Our ref: 12654086

Launceston Private Hospital – Traffic Response to Council Comments

- DA No. DA0377/2024, comments dated 30th September 2024;
- DA No. DA0379/2024, comments dated 1st October 2024
- DA No. DA0380/2024, comments dated 1st October 2024
- The subsequent City of Launceston email dated 15th October 2024, which supplement DA No. DA0379/2024.

Figure 2 Sight distance requirement from Vehicle Access

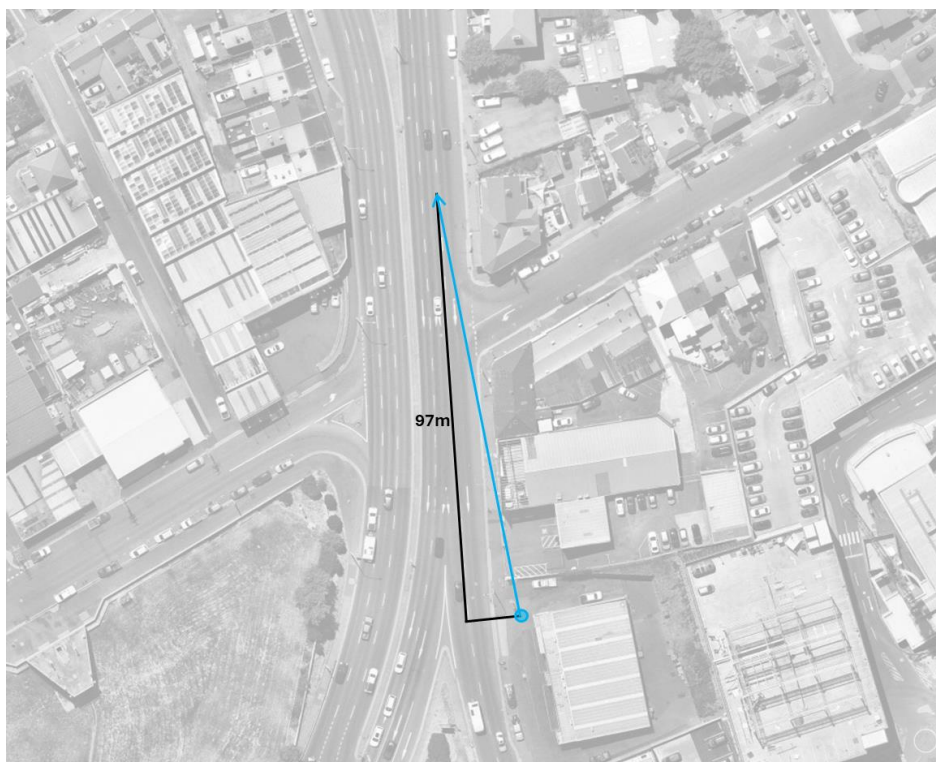
- All loading activity should be required to occur outside of peak traffic times, to further reduce the likelihood of entering vehicles having to wait on Wellington Street for and exiting MRV.
- The crossover used by egressing MRVs is in the same location as an existing crossover, so sight distances should already be compliant. Notwithstanding, a sight distance assessment has been undertaken for the proposed access point (egress only). Wellington Street operates at a speed of 50 km/hr. The Austroads publication, *AustRoads Guide to Road Design –Part 4A: Unsignalised and Signalised Intersections* (2021), requires a safe intersection sight distance (SISD) of 97m for a frontage road with a speed restriction of 50 km/h. The sight distances for MRV's exiting the site in this location are therefore appropriate as shown in Figure 2.

Figure 5 Average Queue Length – Modelled PM Peaks

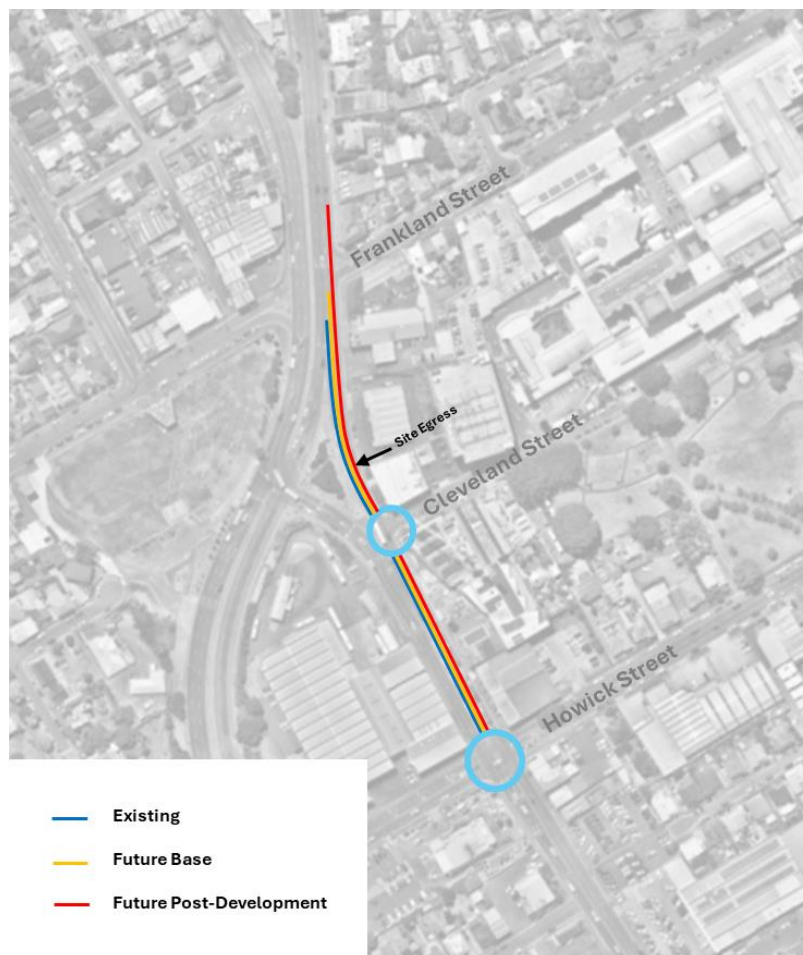
"The TIA does not address whether vehicles will be able to exit the site safely during peak times. The modelling in the TIA for DA0380/2024 shows that the 95th percentile queues on Wellington Street are over 160m back from Howick Street and are expected to increase to 180m. The exit from the car park is also around 160m from Howick Street. It is noted that this modelling does not consider the traffic signals at Cleveland Street, which create queues that extend well past this site. A large proportion of vehicles exiting the car park will wish to turn right at Howick Street to head north or south on the Southern Outlet. These vehicles will need to cross two lanes of traffic in order to get to the right turn lane at Howick Street. It is also noted that a number of the crashes in this section of Wellington Street relate to changing lanes.

- “Advice demonstrating that there is an appropriate level of service for vehicles to safely exit the car park onto Wellington Street during peak times, given:
 - The high traffic volumes on Wellington Street,
 - Vehicles queuing from the traffic signals at Howick Street,
 - Vehicles queuing from the traffic signals at Cleveland Street.”
- “Advice demonstrating that vehicles exiting the site can safely access the right turn lane at Howick Street.”

It is acknowledged that queues on the north approach to the Wellington Street / Cleveland Street intersection currently extend beyond the subject site, particularly in the PM peak as shown in Figure 5. This queue is anticipated to further extend with background traffic growth and again based on the development. It should be noted that the development traffic is a low proportional of the total traffic traversing this segment. During these periods it is expected that vehicles egressing from the subject site in future would need to rely on courtesy gaps in order to exit the subject site. Given the absence of any on-street parking in the area the view of vehicles exiting the subject site is unobstructed to traffic on Wellington Street and it is expected that there would be reasonable opportunity for these courtesy gaps to exist, given the reduction to speeds induced by this queueing.

Egressing in this manner is not expected to negatively impact the safety of drivers that need to access the right turn lane into Howick Street. During periods of congestion, speeds will be significantly reduced and safety risk is lowered at such speeds. However, the impact of additional lane changing is observed to reduce the Level of Service on the north approach to the Wellington Street / Cleveland Street intersection in

On this basis, site generated traffic that needs to make this manoeuvre is not expected to significantly exacerbate lane changing risks on Wellington Street between the site egress point and Howick Street. Approximately five minor crashes related to lane changing have occurred within this region in the past five years. The site generated traffic that need to access the right turn into Howick Street is not expected to exacerbate any present risks associated with these lane changes, as they are occurring more than 60m north of the site egress point.

Figure 6 Level 2 ramp manoeuvring and visibility mitigations

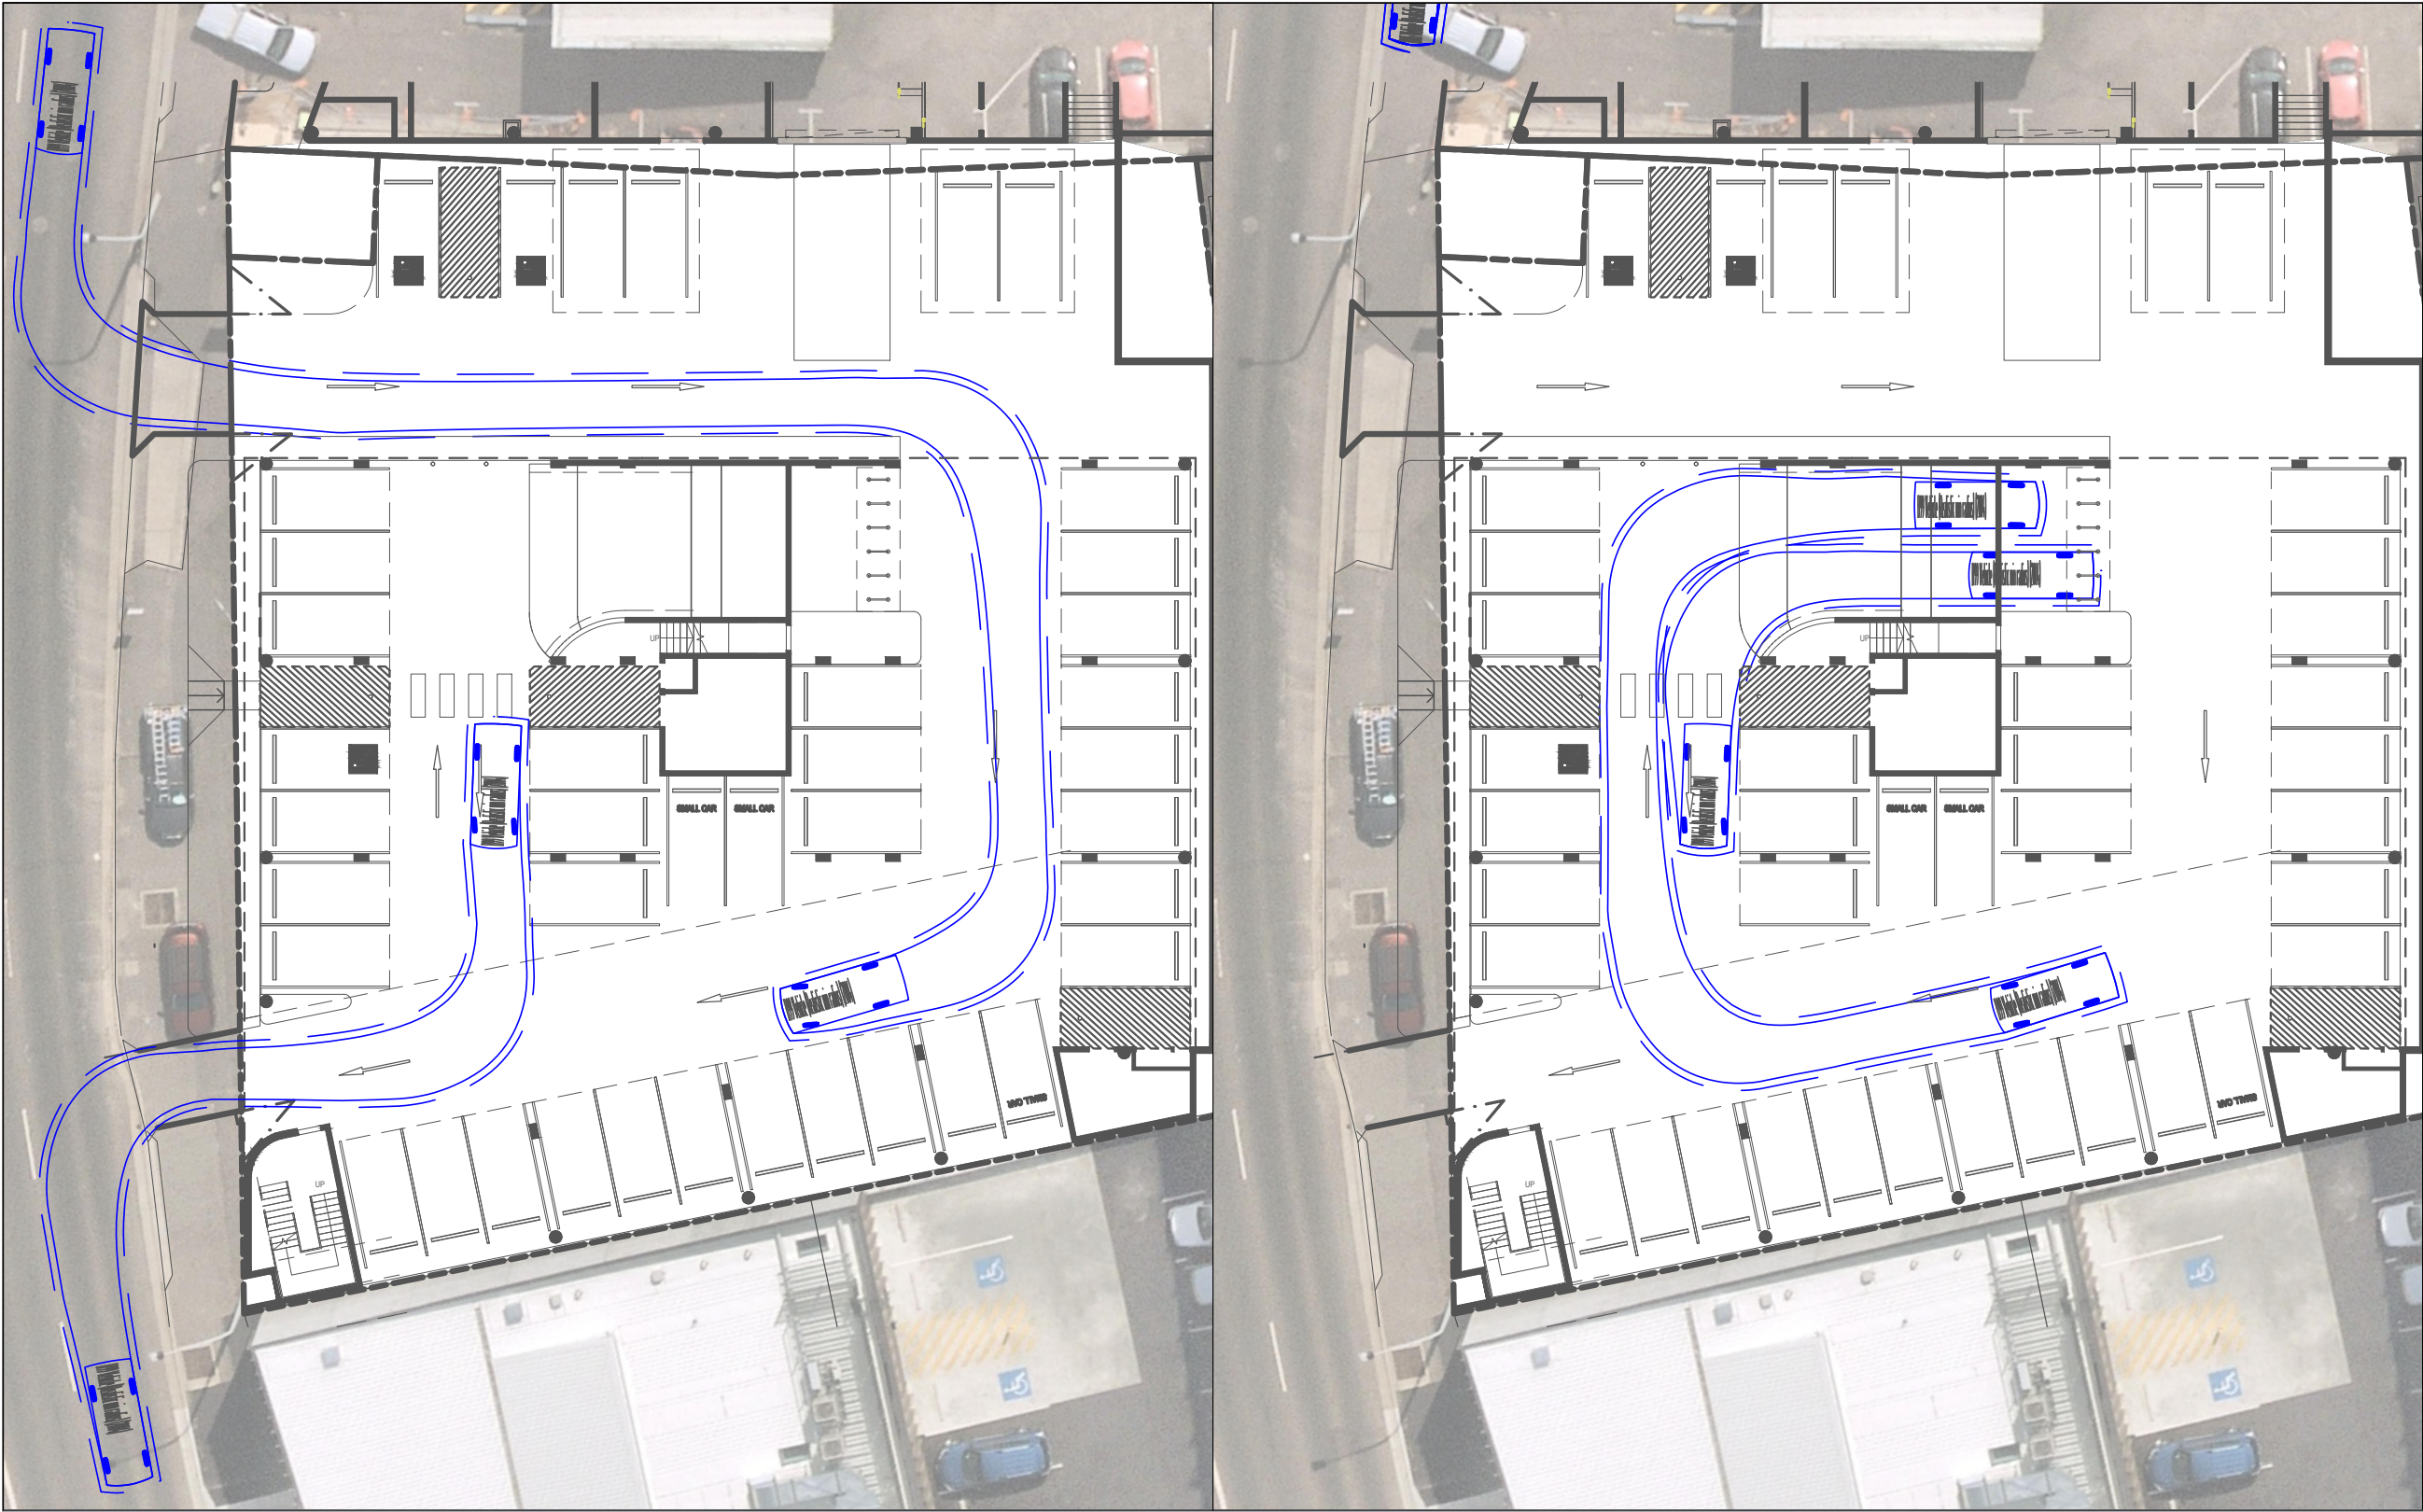
“It is also noted that for vehicles to head down the ramp from Level 2 of the car park, they need to pull to the far left of the circulating lane and do a hard right turn, as shown in Figure 4. Some sort of guidance, such as signage or delineation, should be provided to advise users of the car park where to position their vehicle to undertake this manoeuvre.”

- "Advise how the conflict between the Medium Rigid Vehicle swept path and the proposed column in the loading area can be resolved."
- "Address the manoeuvring into the down ramp at level 2 as shown in figure 4 and obstructed sight lines and potential conflict between vehicles coming up the ramp to level 2 and vehicles turning to go down the ramp."
- "Address advisory signage regarding location of motorcycle, bicycle and accessible parking."
- "Address possible consolidation of the two accessible parking spaces on level 3 to a single location adjacent to the lift lobby."

- The column conflicting with the MRV swept path has been shifted to the north, such that this conflict no longer exists. Please find updated swept paths within Attachment A to this letter.
- The following interventions have been applied within the level 2 car park design:
 - Line marking to guide vehicle movements around the curve, into the ramp.
 - Mirror for drivers on level 2 that provides visibility of any vehicles that are potentially on the ramp.
 - Stop line so that vehicles on level 2 stop to look and give way.

The layout of these mitigation measures is shown in Figure 6.

Launceston Health Club
217-229 Wellington Street, Launceston
B99 Design Vehicle (B99)
Site Access and Circulation
Ground Level

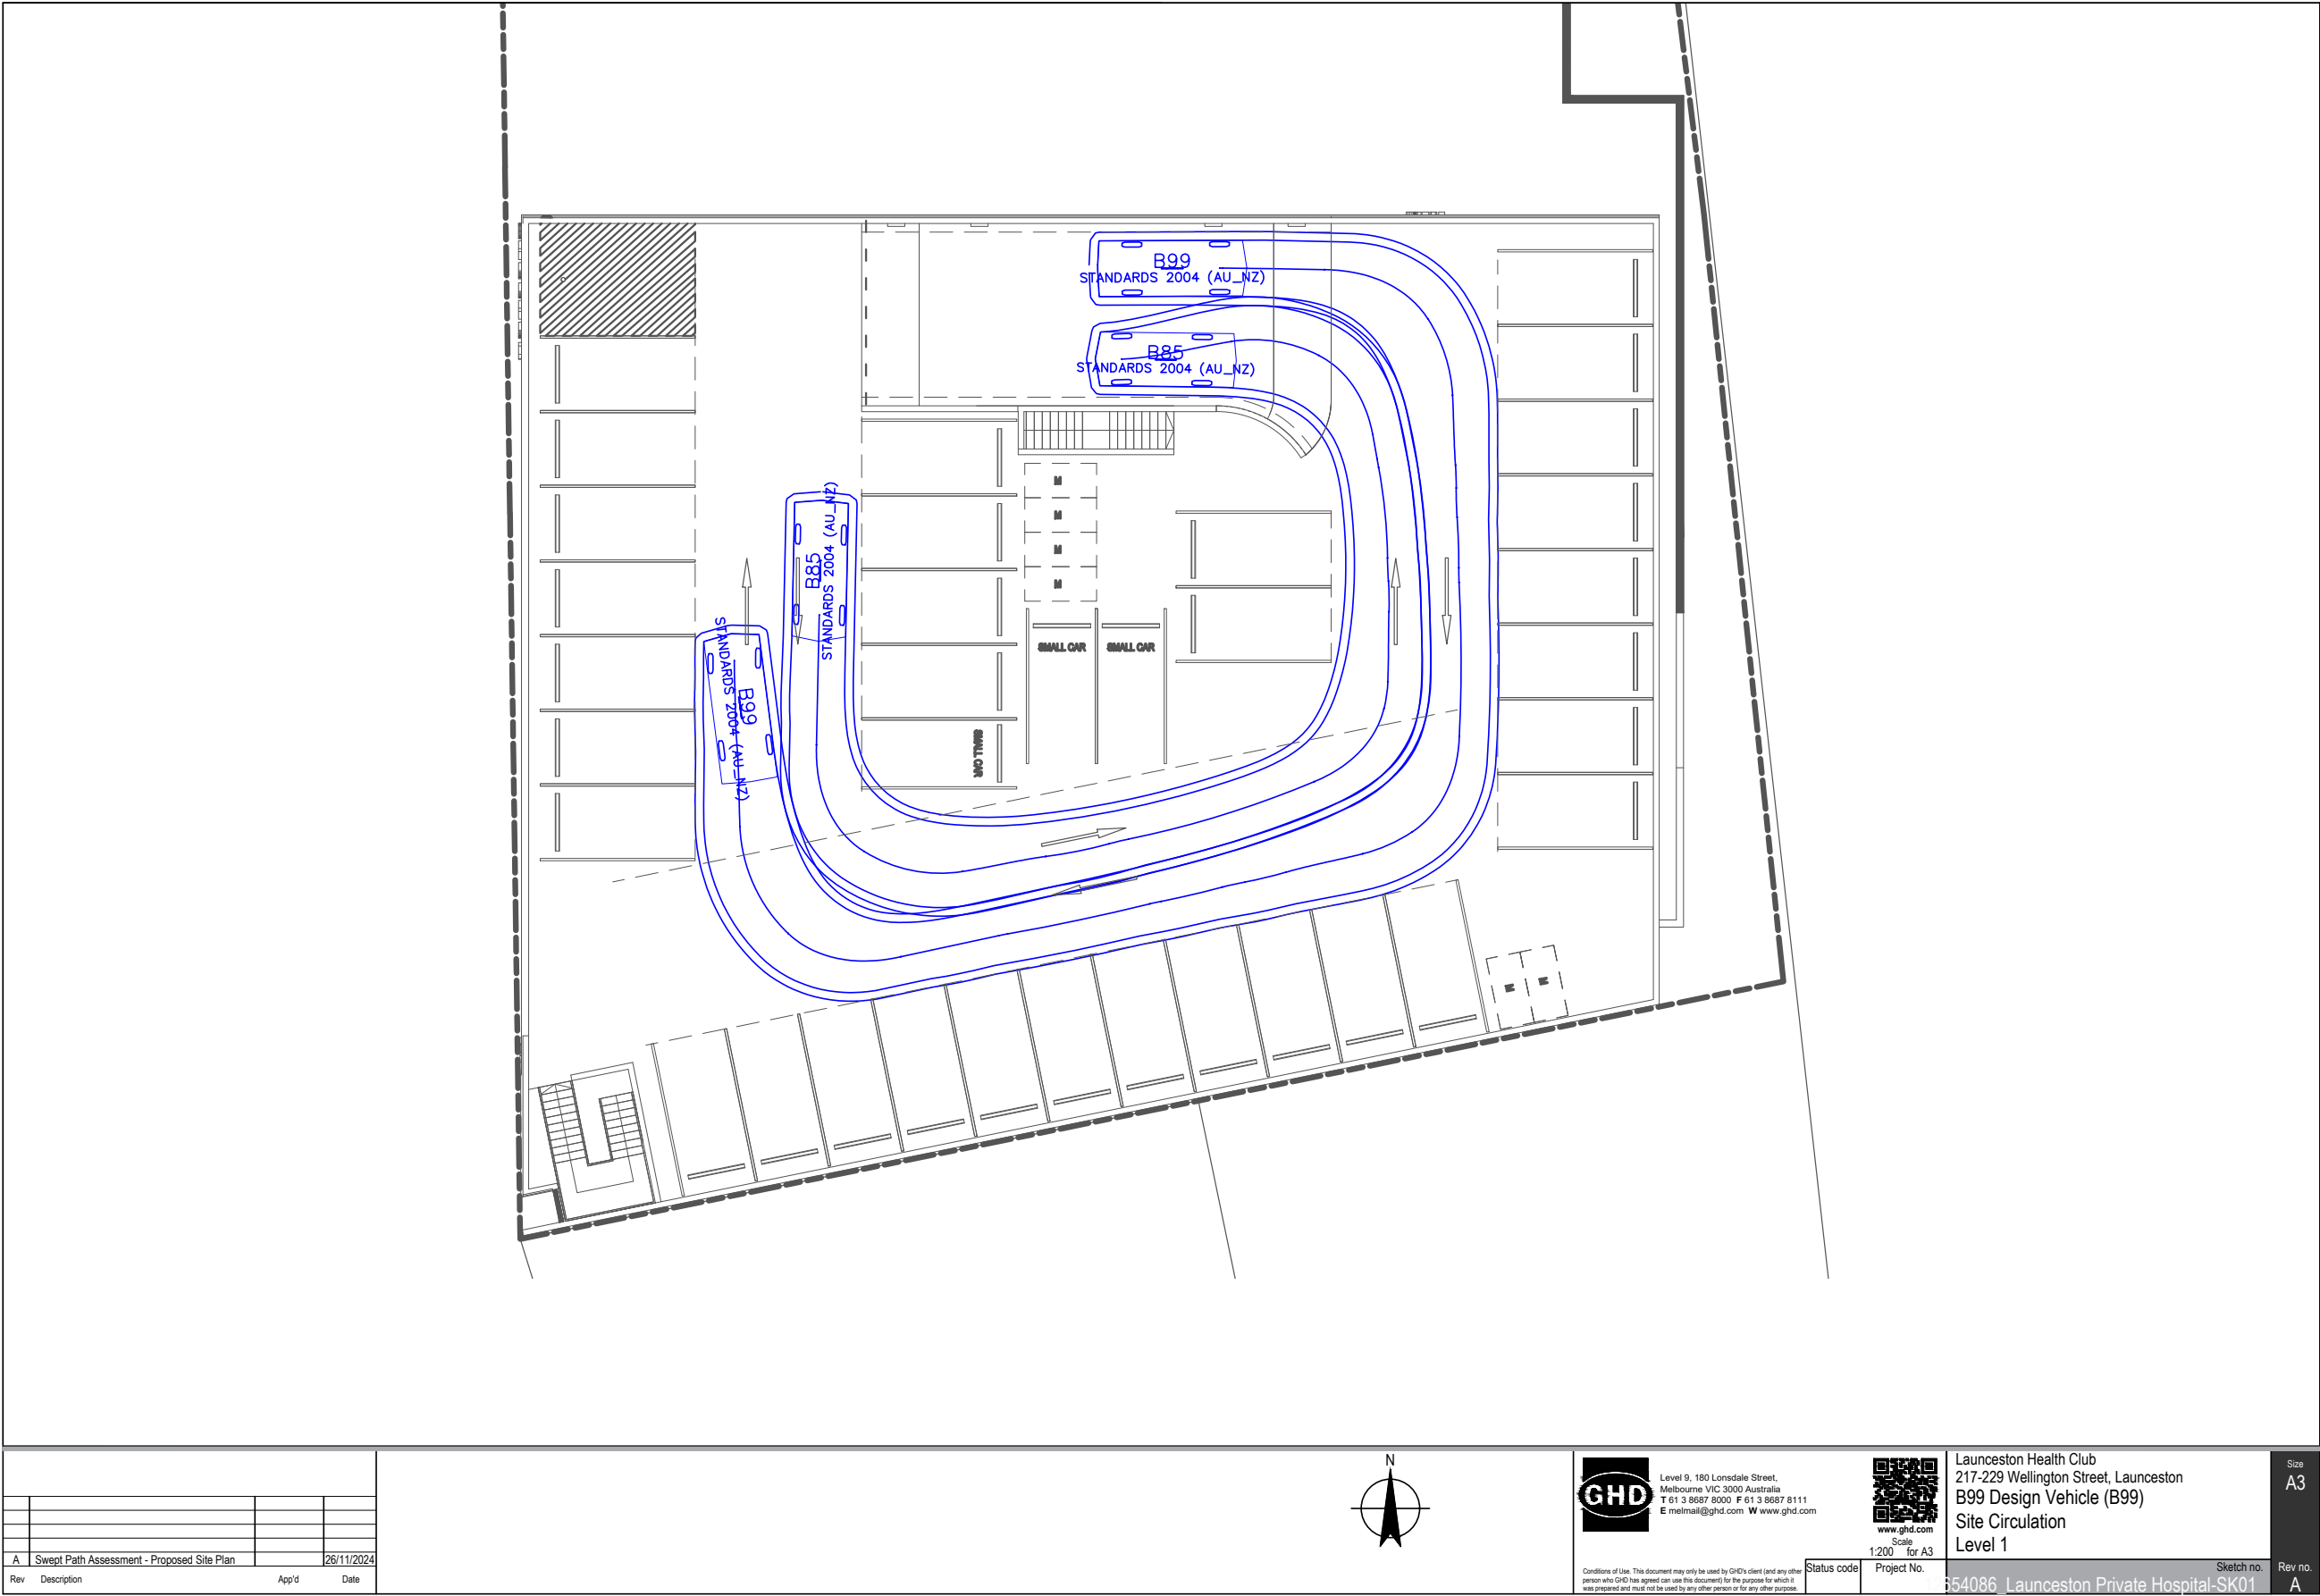
"The swept paths for the second level of the car park show the anti-clockwise vehicle movement completely in the oncoming lane, as shown in the image below. This is not acceptable."

"Revised plans with appropriate swept paths."

Please find revised swept paths within Attachment A to this letter.

The swept paths have been revised to more appropriately show simultaneous movement of a B99 & B85 design vehicle through level 1 of the proposed car park at 217-229 Wellington Street, Launceston. Level 2 of the car park is proposed to be built as part of the hospital expansion (DA No. DA0380/2024) and will be a one-way circulation zone.

It is noted that there are two locations where the swept paths are shown to overlap an individual car parking space. As communicated via email with the City of Launceston on 25th November 2024, the overlap is conserved acceptable on the following basis:

- Simultaneous right turns are unlikely to occur very often as space turnover is expected to be low and movements are generally tidal (majority in during AM, out during PM).
- There is sufficient space for one vehicle to store in the adjacent access lanes whilst the other completes the manoeuvre around the corner. This provides an option for the occasions, which are considered to be low occurrence, when two vehicles do need to make this manoeuvre in opposing directions.
